工程指示 / 要求簡箋(E.I.)

工程指示編號：EI / 7232 / 24                      修改版次：B  
 工程編號           ：J - 858                              工程名稱       ：將軍澳日出康城  
 工程項目           ：後加 AC Grille (T2 9/F AF Mock Up) 圖紙上載 2<sup>nd</sup> submission  
 收件人               ：生統 / 拆圖                              發件人        ：Paul Wong                              日期：22/02/2024

**PROPOSED RESIDENTIAL DEVELOPMENT  
AT TKOTL 7ORP, PHASE 11, LOHAS PARK, TSEUNG KWAN O, N.T.**

**TITLE : SHOP DRAWING FOR  
ALUM. A.C. GRILLE & WATER CABINET AT 9/F FOR TOWER 2A-FLAT F (MOCK UP)**

TITLE :  
 ALUM. A.C. GRILLE & WATER CABINET  
 AT 9/F  
 FOR TOWER 2A-FLAT F  
 TYPICAL DETAILS

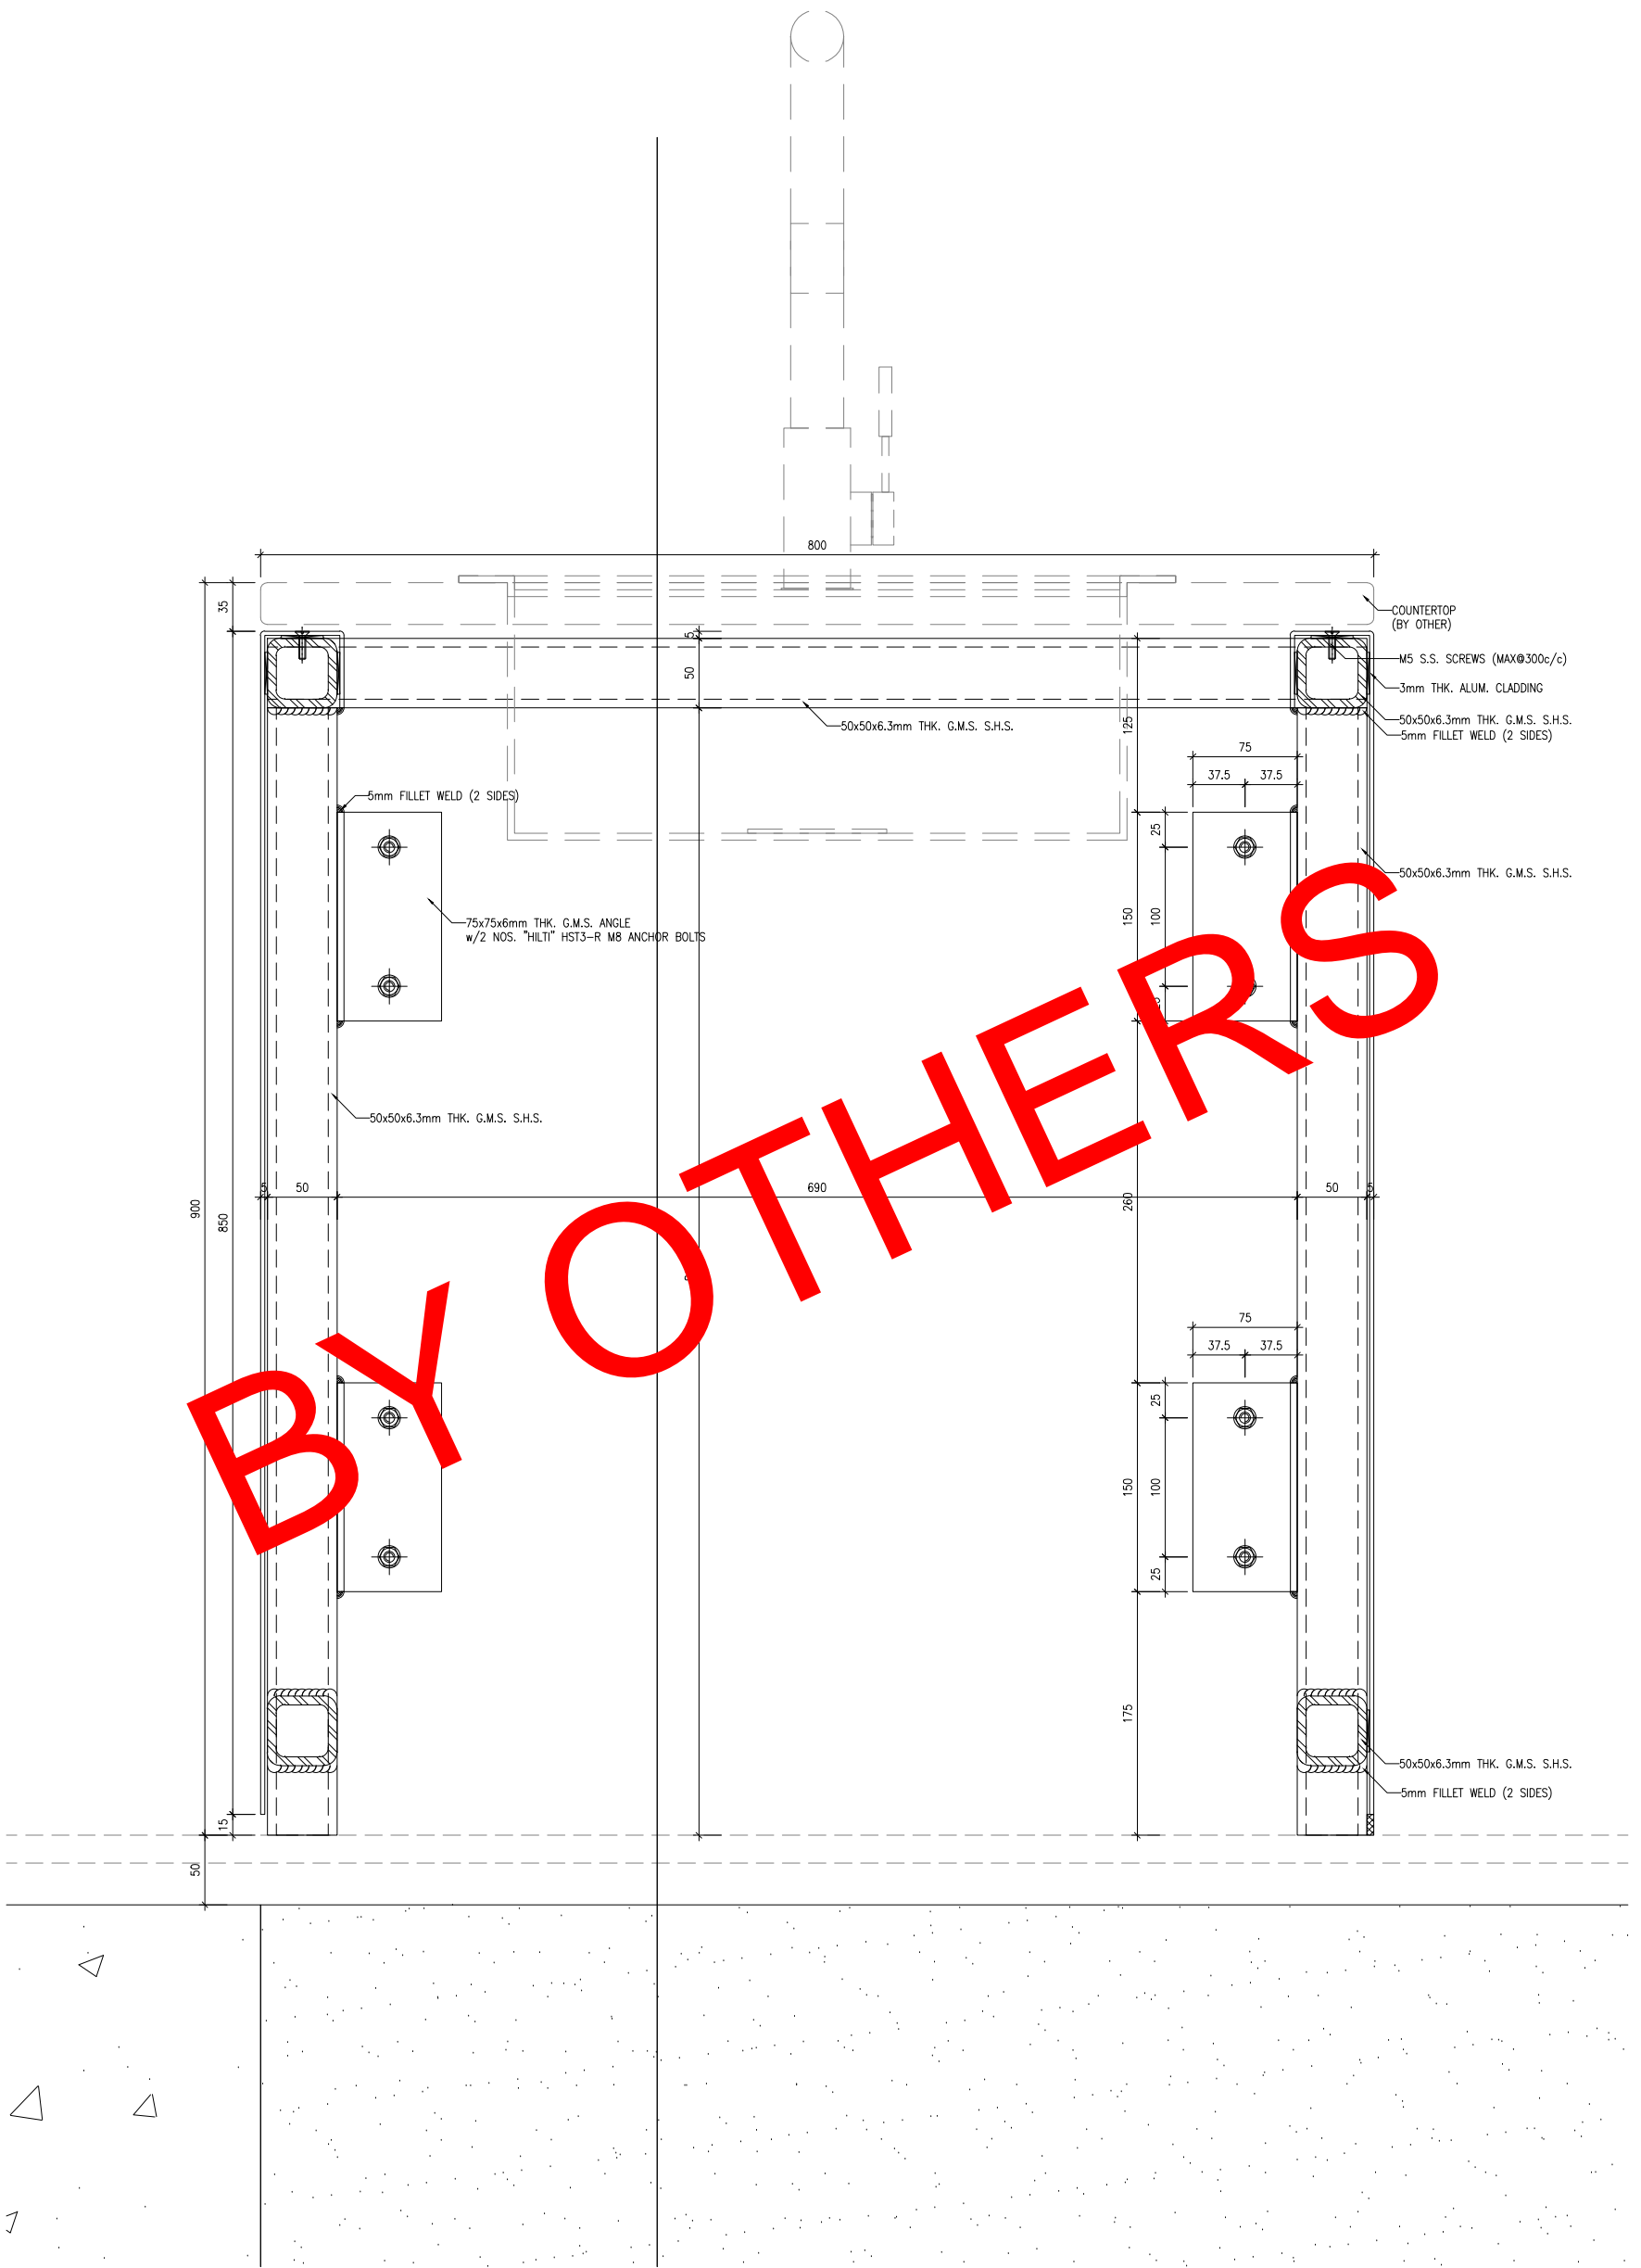
WATER CABINET REMOVED FROM MIDÍ'S SCOPE BY CLIENT

TITLE :  
 ALUM. A.C. GRILLE & WATER CABINET  
 AT 9/F  
 FOR TOWER 2A-FLAT F  
 TYPICAL DETAILS

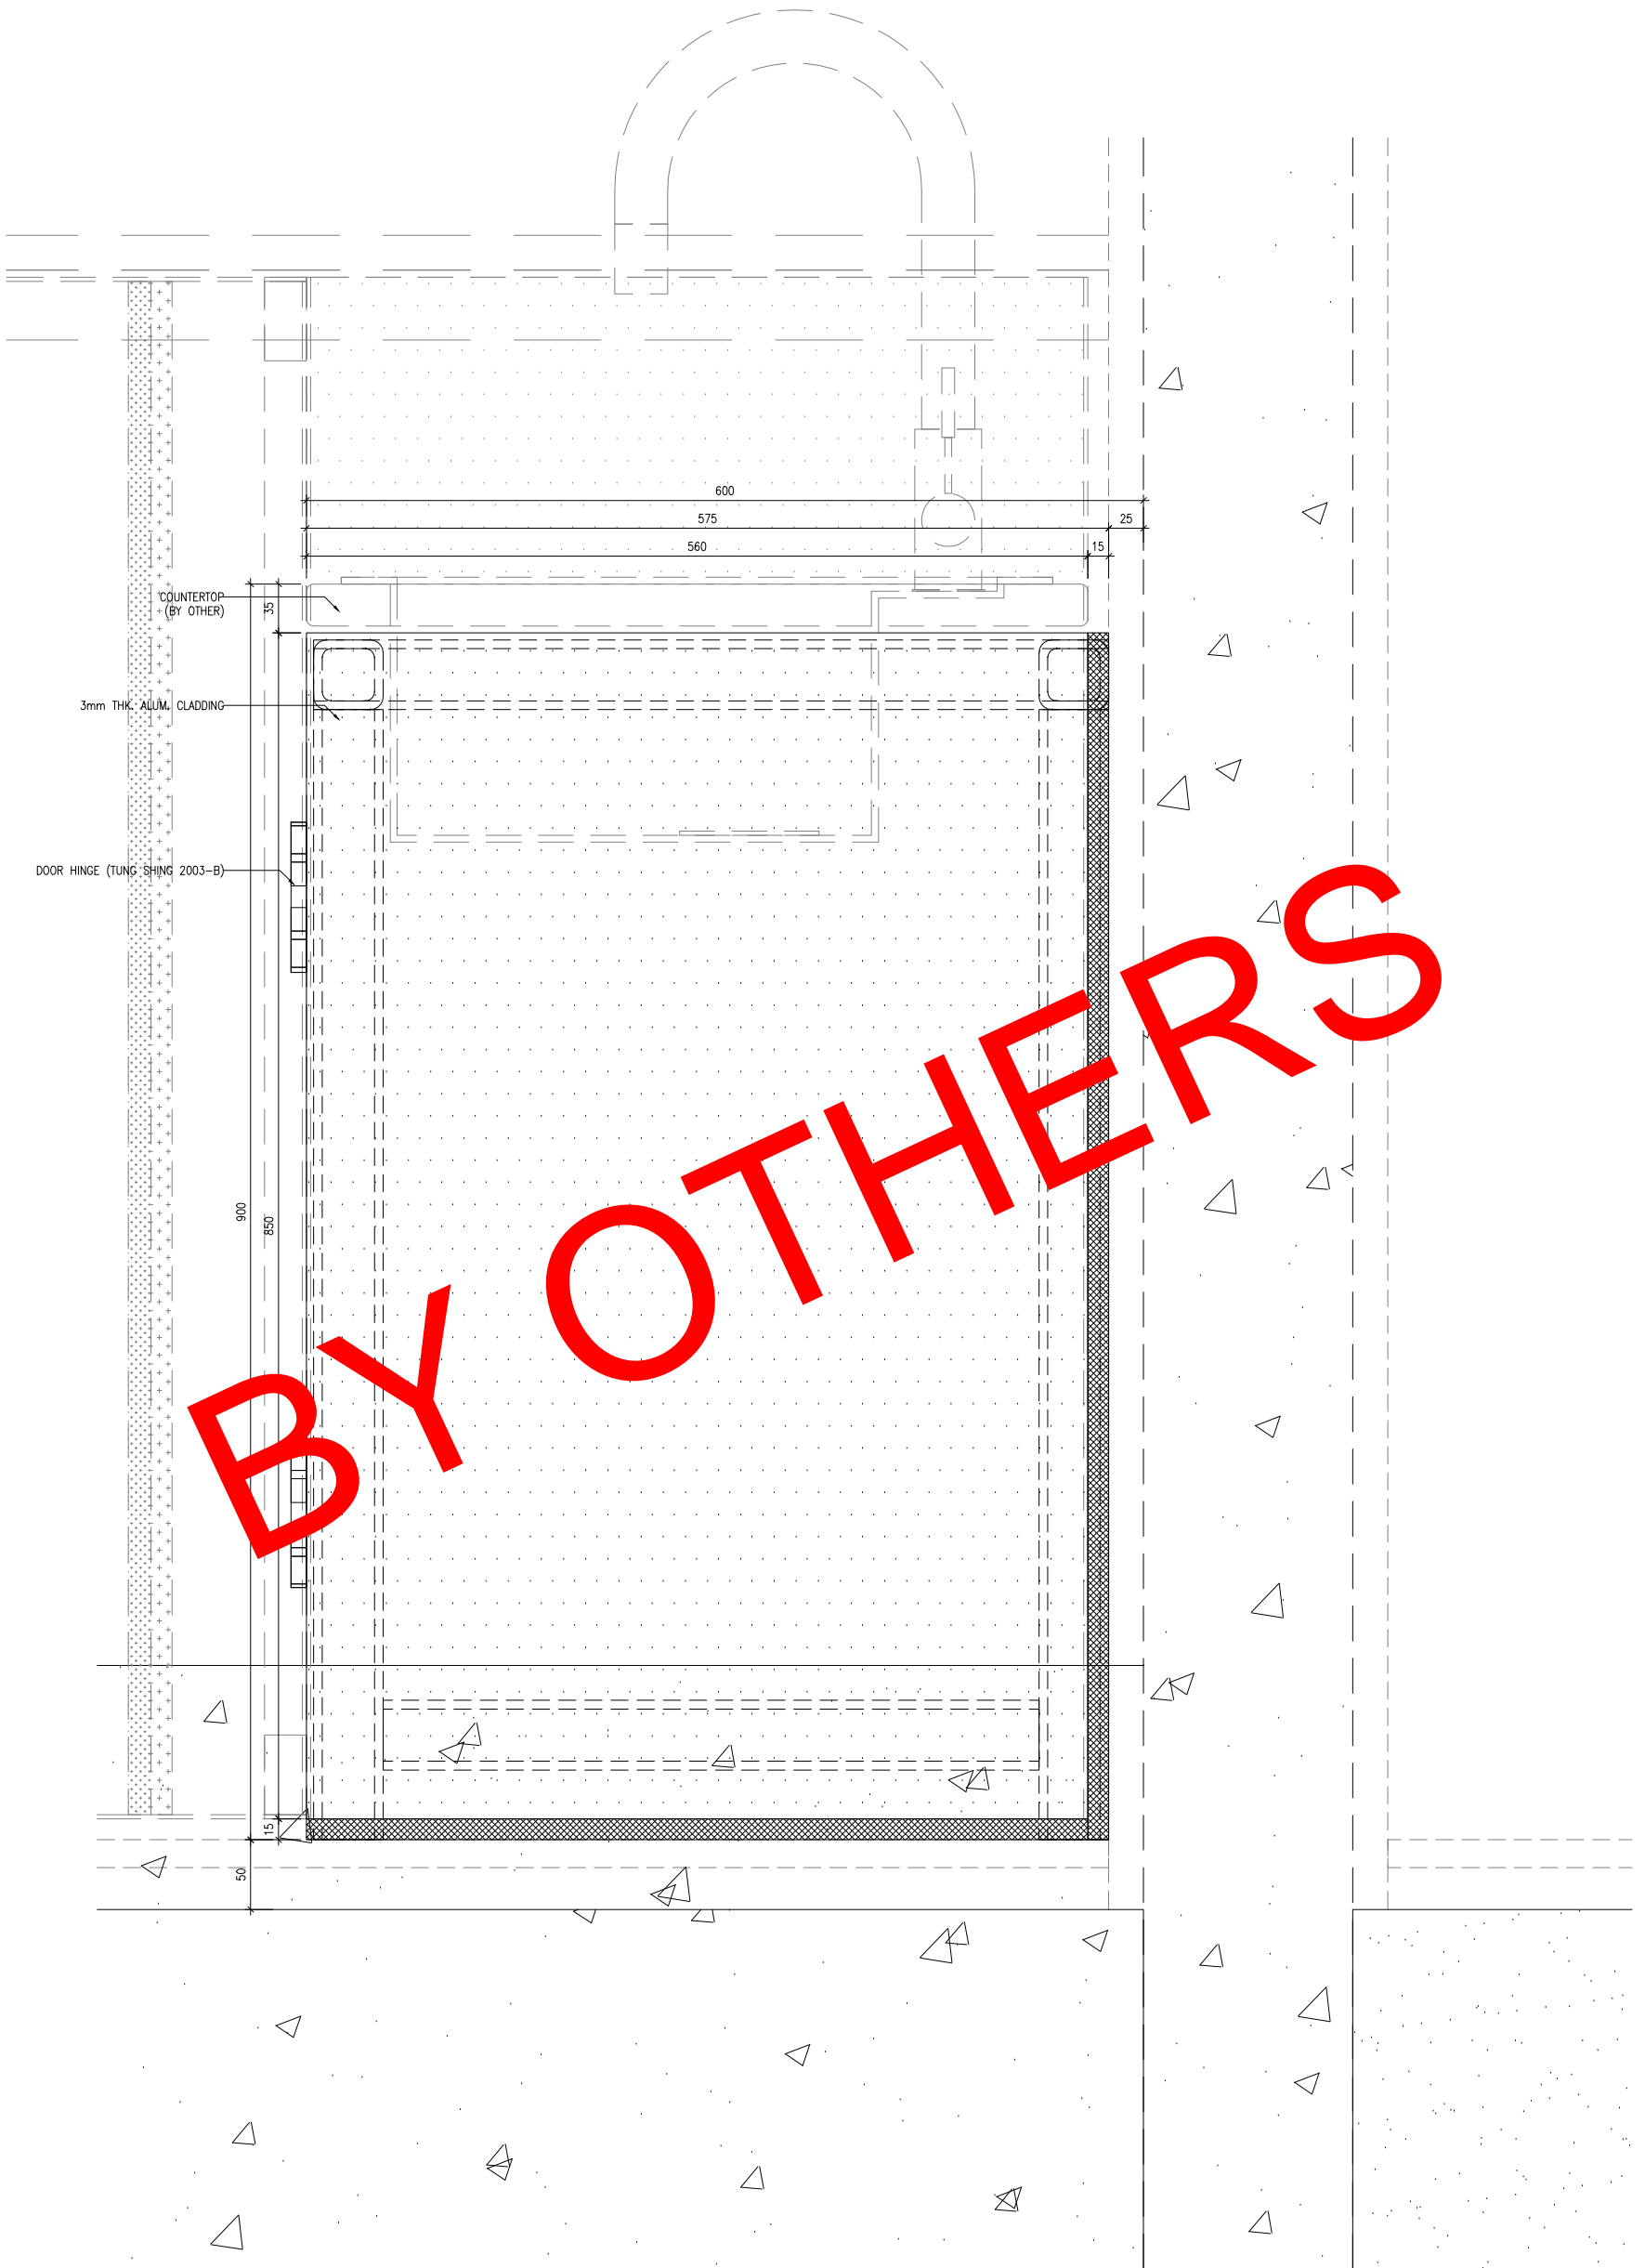
WATER CABINET REMOVED FROM MIDÍ'S SCOPE BY CLIENT

TITLE : ALUM. A.C. GRILLE & WATER CABINET AT 9/F FOR TOWER 2A-FLAT F TYPICAL DETAILS

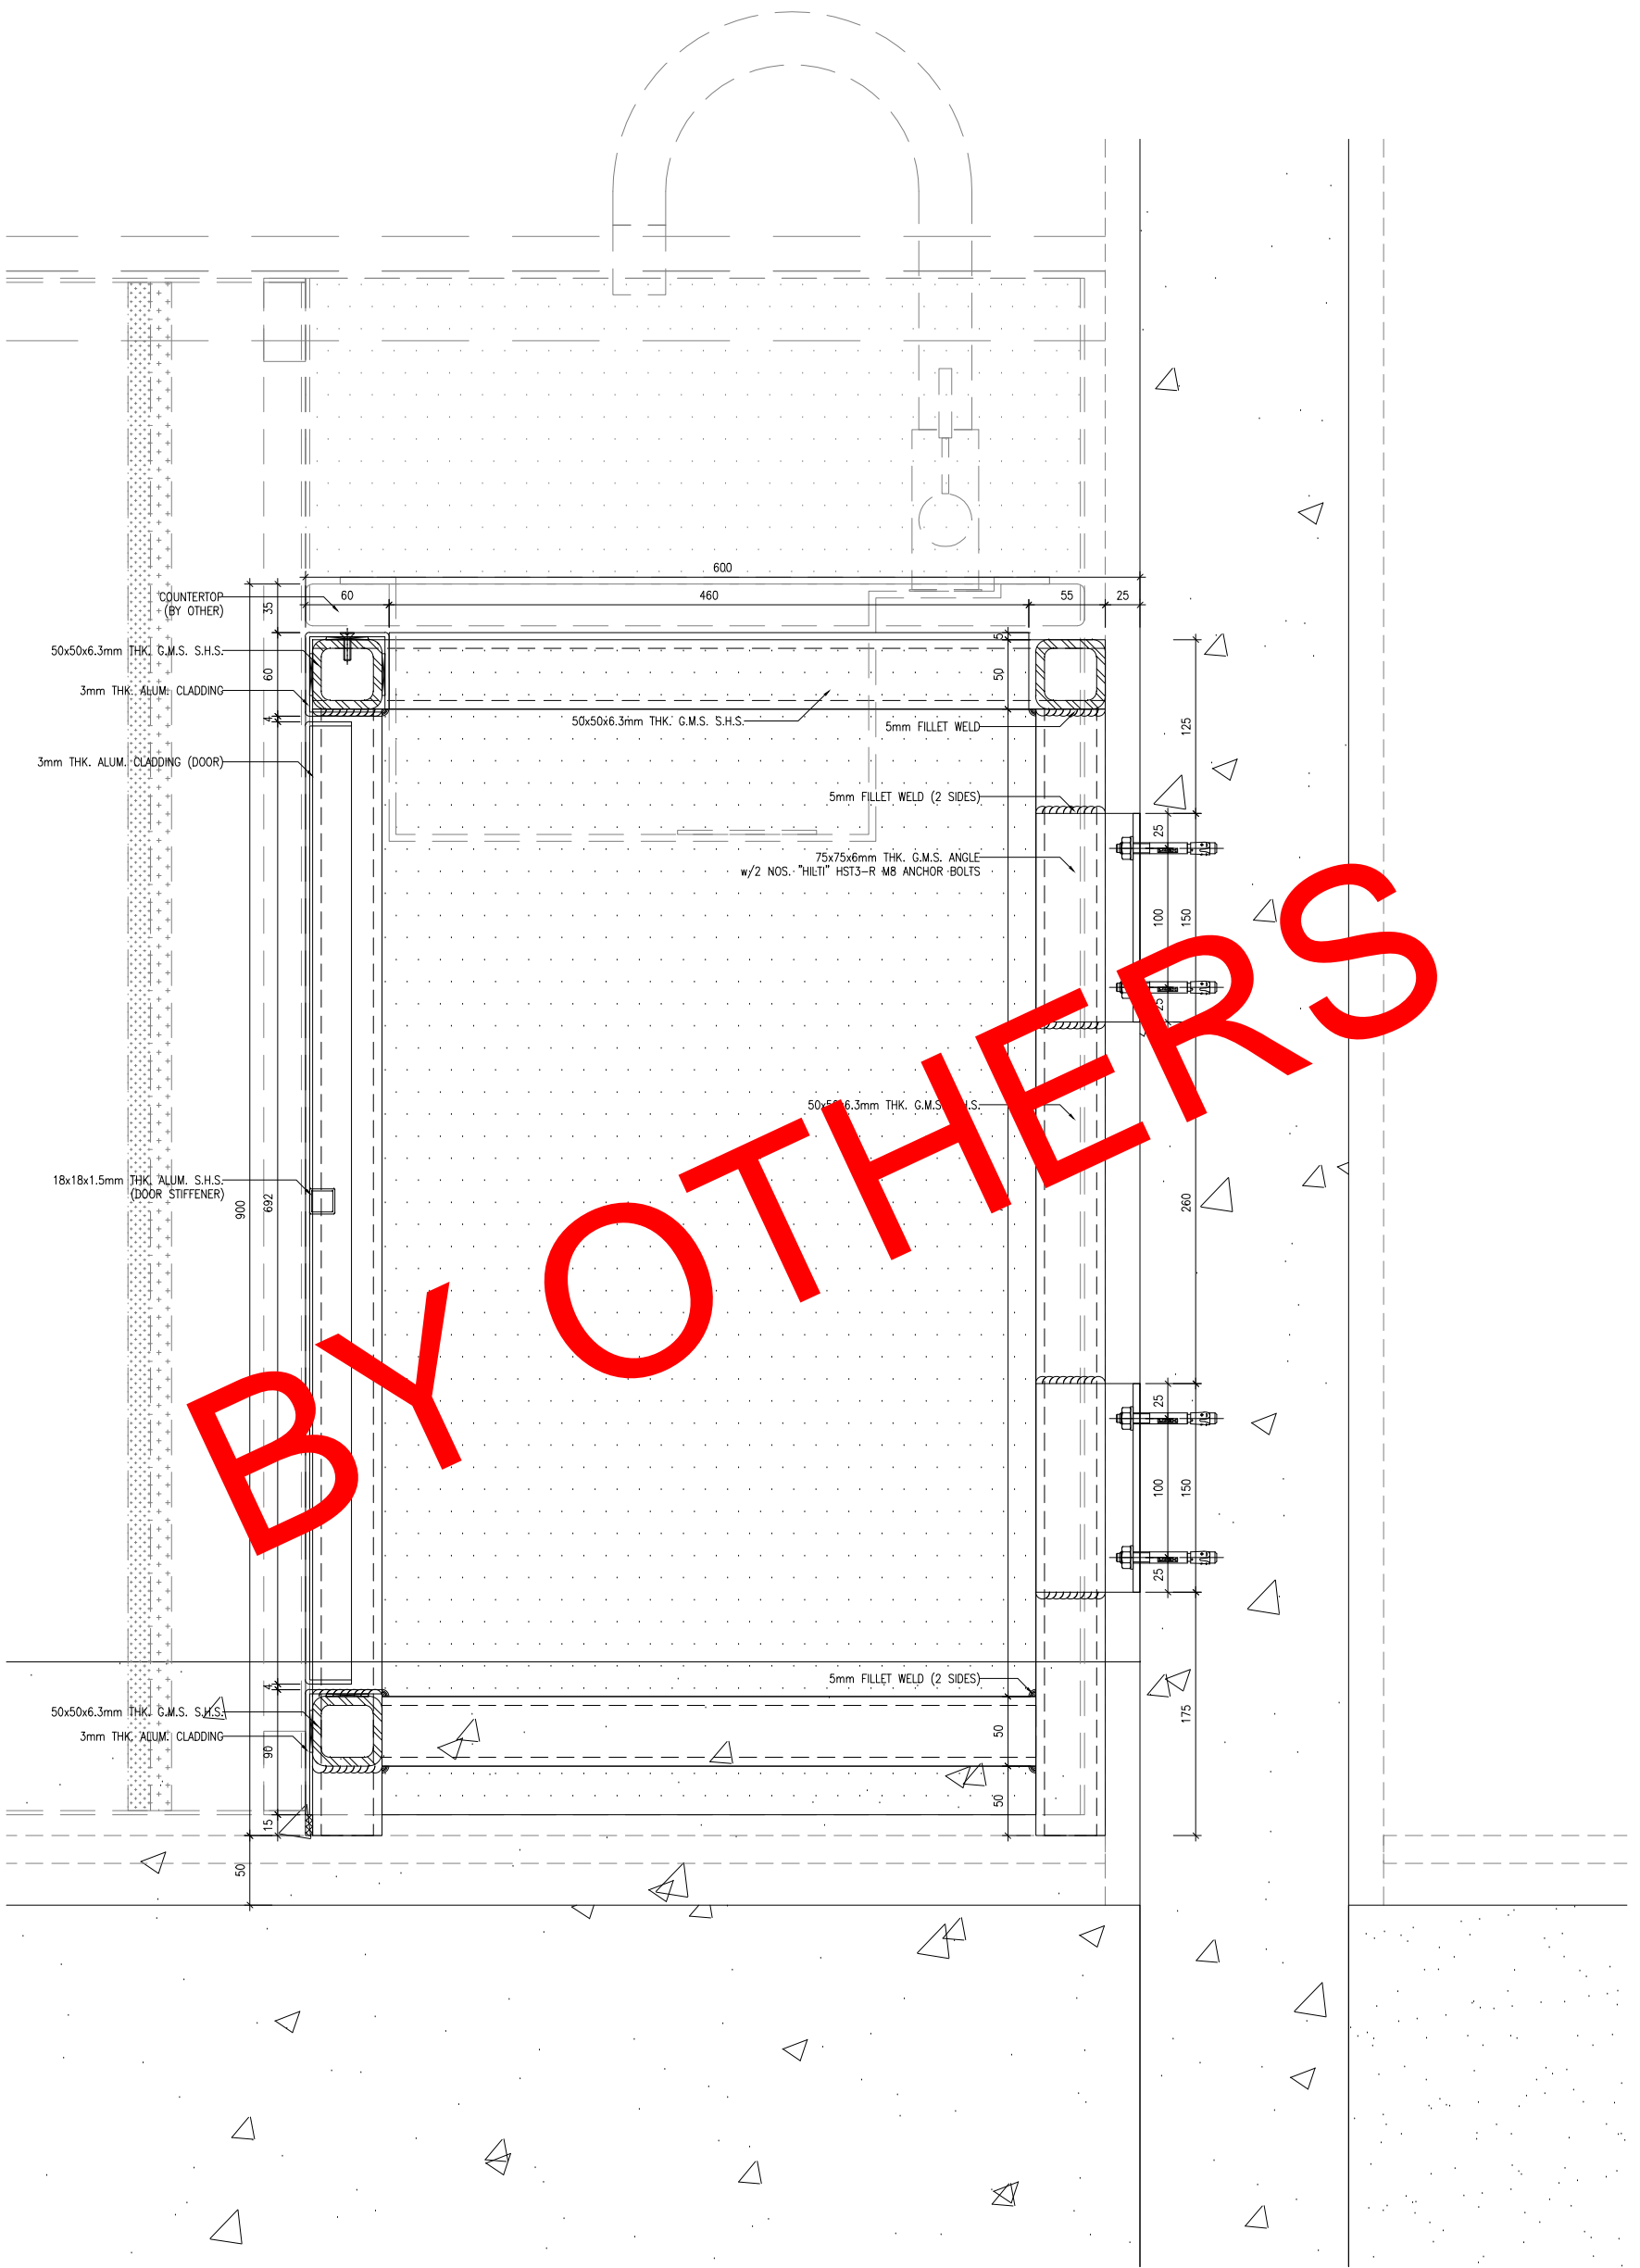
WATER CABINET REMOVED FROM MIDİ'S SCOPE BY CLIENT
